Office Action Summary

10/511,906

DETAILED ACTION

This office action is in response to the amendment and remarks filed 6/22/07. Since the examiner has applied new grounds of rejection, this office action is being made non-final to afford the applicant the opportunity to respond to the new grounds of rejection.

FIG. 8

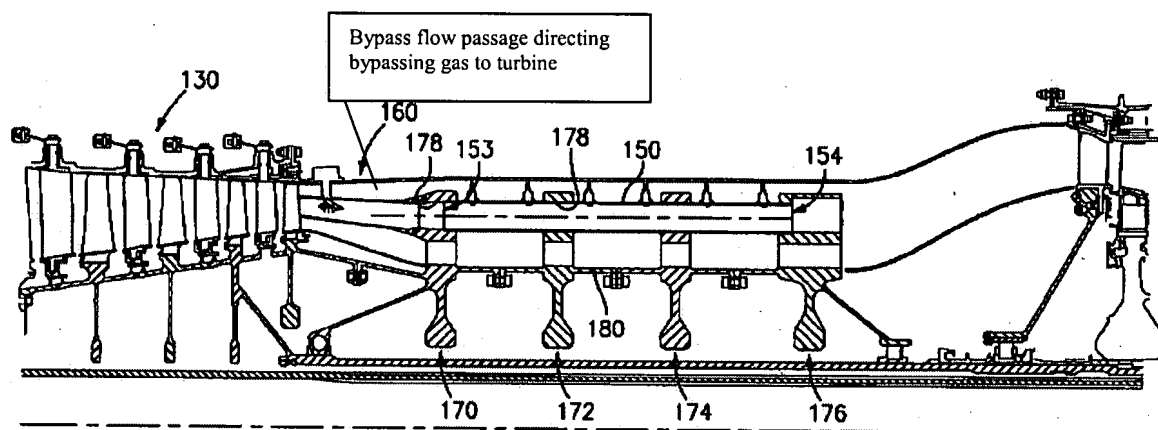
Nordeen (particularly Figures 5 and 8) teaches a pulse detonation engine comprising: a gas supply section (compressed air from compressor 130), a fuel supply section 190, a detonation generator section including a detonation tube 150, an igniter 32 for igniting the mixture of gas and fuel in the detonation tube, a turbine section 136 driven by impact energies of detonations, the detonation generator section including a shock alleviating section 134, said turbine section including a first turbine (high pressure turbine) and a second turbine (a low pressure turbine) mounted on a common shaft, said common shaft being rotated by motive power converted from drive force generated by the turbine, and a bypass flow passage for bypassing a portion of said gas to the turbine (cl. 3 ll. 49-52), wherein said turbine rotation can be used to generate electric power to drive accessory equipment of said gas turbine.

With regards to the method claims, since Nordeen has the same structure as claimed, it is inherent that Nordeen's device would be able to perform the recited method steps.
